CORRECTIONS BY	<u>G. CUNNINGHAM/ RWH</u>
CONTRACT NO.	<u>1296-NMC-0130</u>
DATE	<u>5-8-01 / 6-1-01</u>

TRABUCO CREEK BIKE TRAIL OVERCROSSING

SECTION AT END DIAPHRAGM

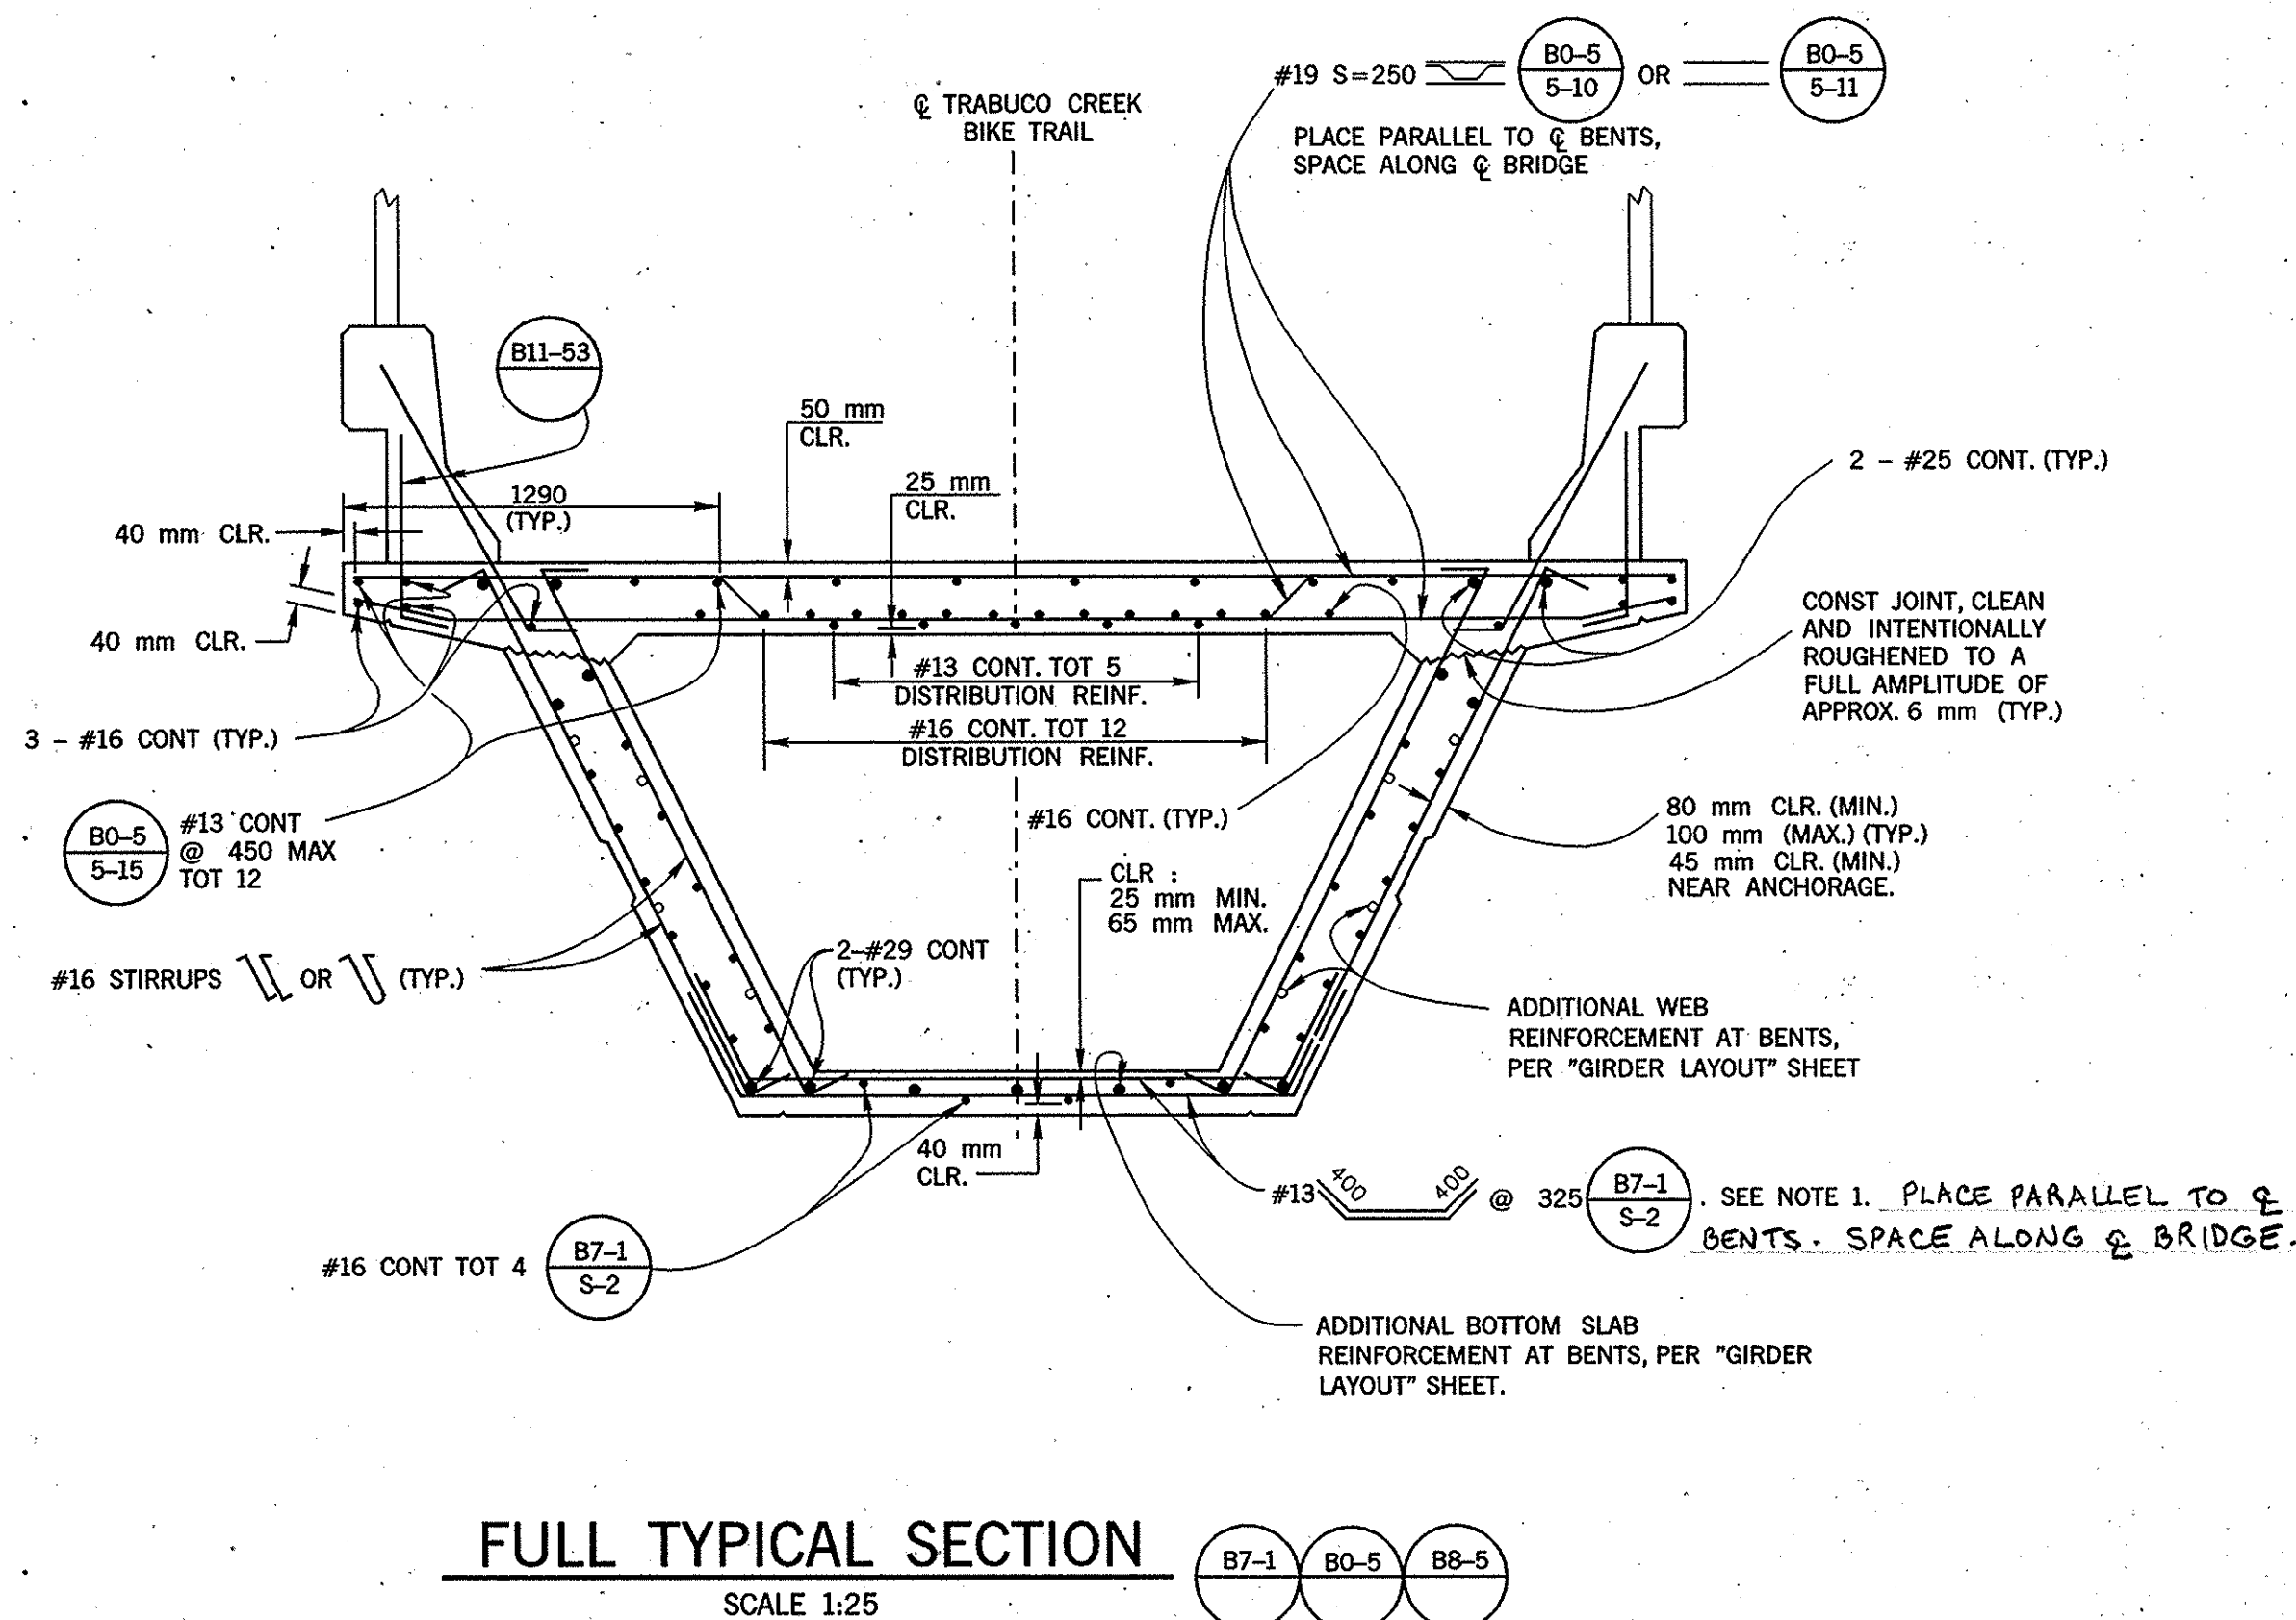
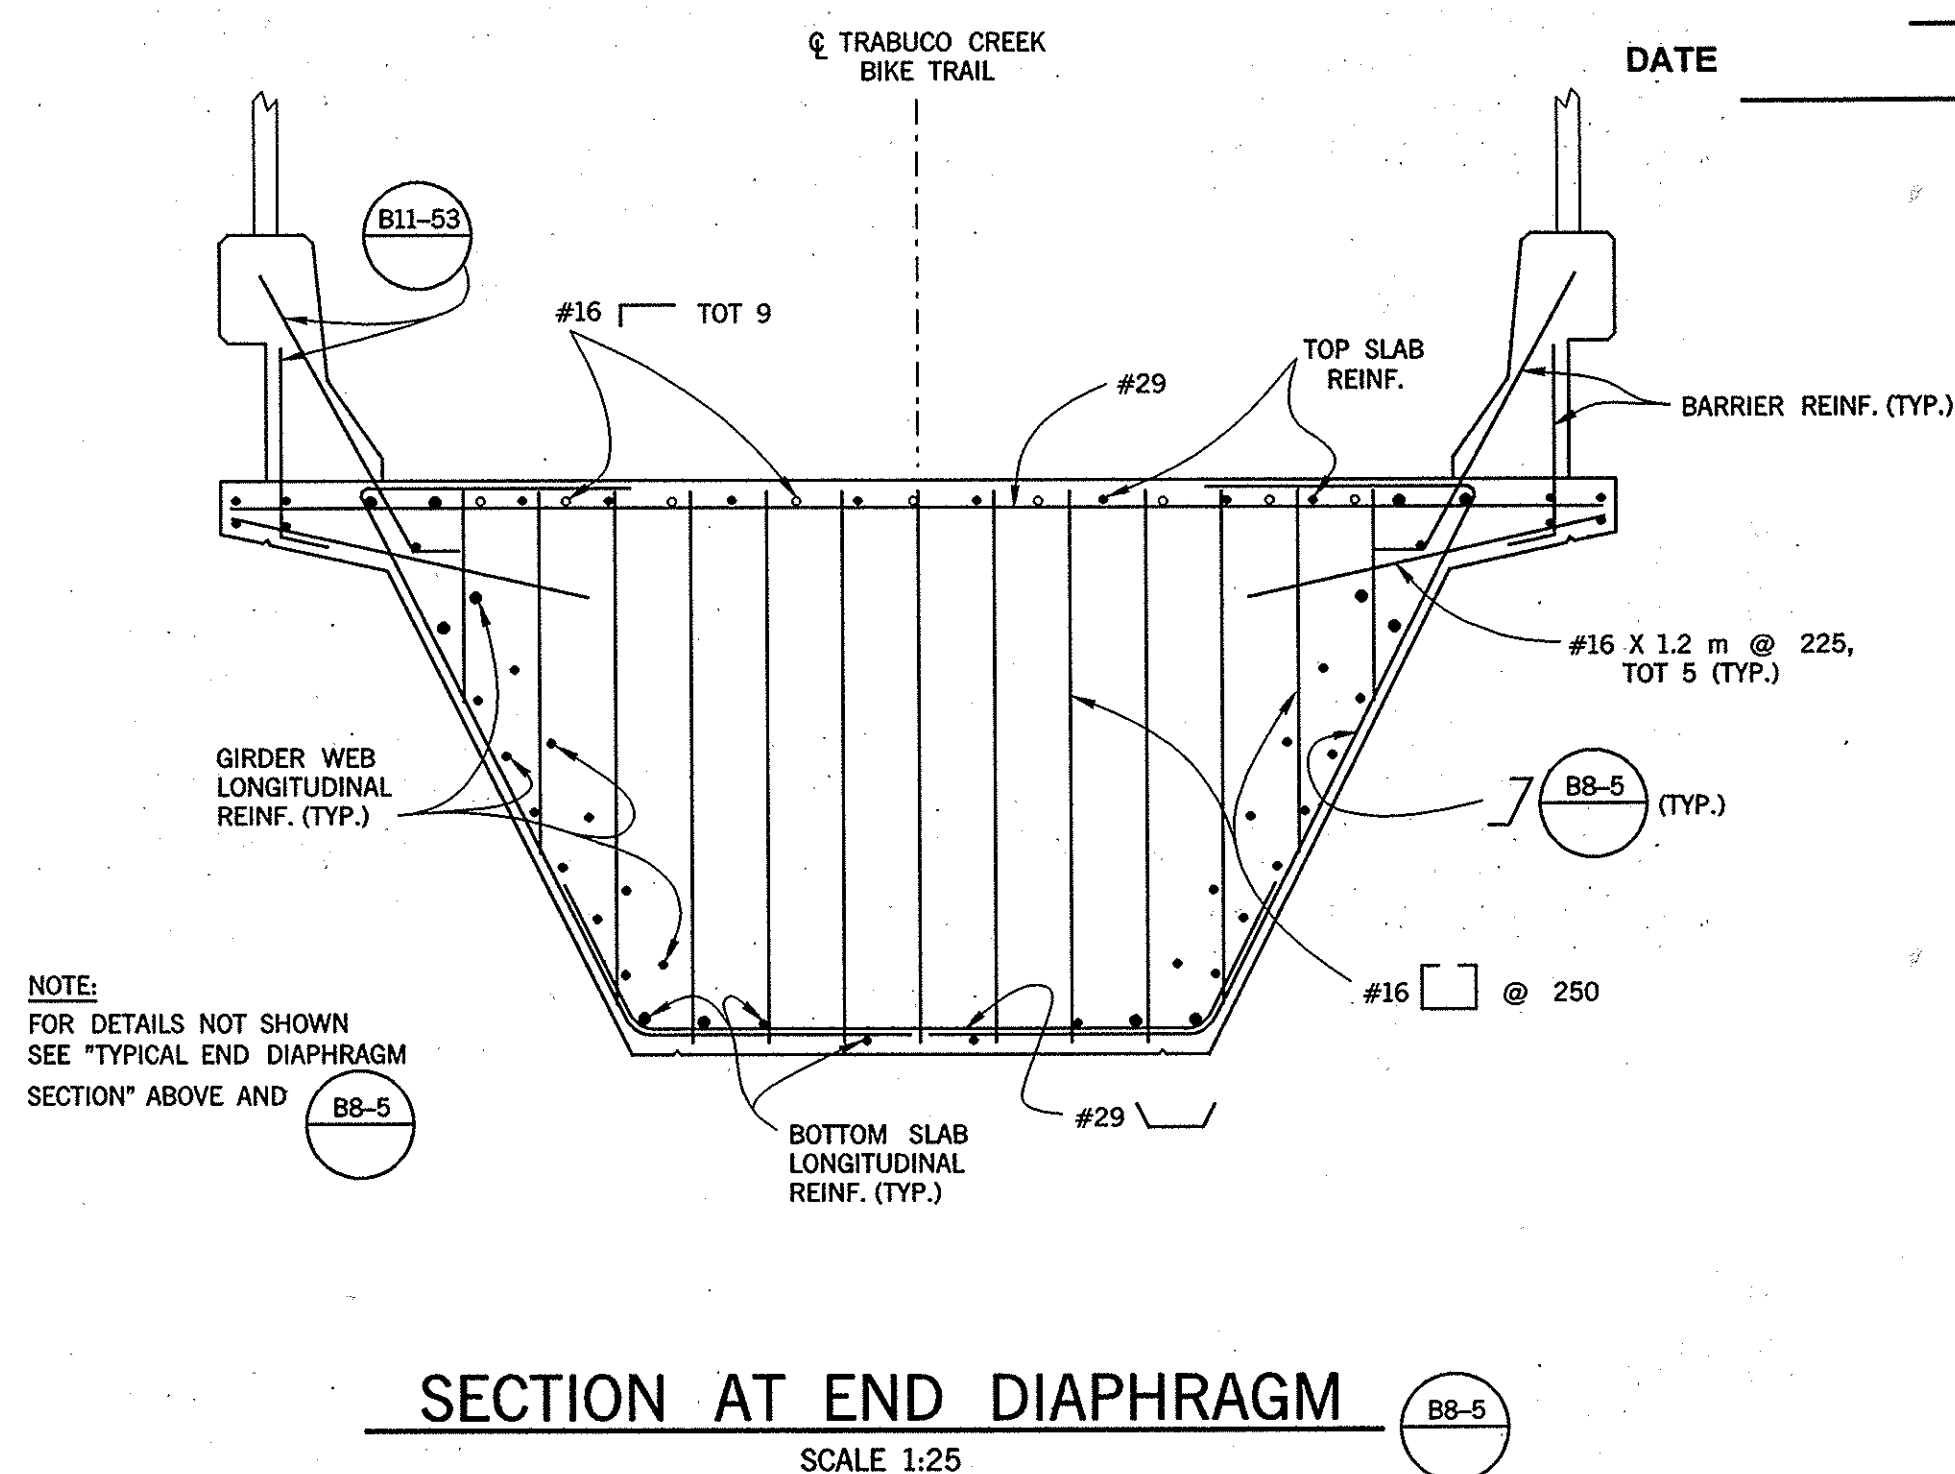
1. FOR ADDITIONAL REINF. IN TAPERED PORTION OF BOTTOM SLAB, SEE "BENT DETAILS No. 2" SHEET.
2. SPICING OF SUPERSTRUCTURE LONGITUDINAL REINFORCEMENT :
NO SPICING OF BOTTOM SLAB LONGITUDINAL REINFORCEMENT ALLOWED WITHIN 1/6 SPAN LENGTH, i.e. L/6, ON EITHER SIDE OF :
 - a. MID-SPAN, @ INTERMEDIATE SPANS, AND
 - b. 3L/8 FROM ℄ BEARING ABUTMENT @ END SPANS.NO SPICING OF TOP SLAB AND WEB LONGITUDINAL REINFORCEMENT ALLOWED WITHIN 1/6 SPAN LENGTH, i.e. L/6, ON EITHER SIDE OF ℄ BENT.
3. FOR VARYING SOFFIT AND WEB THICKNESSES, SEE "GIRDER LAYOUT" SHEET.
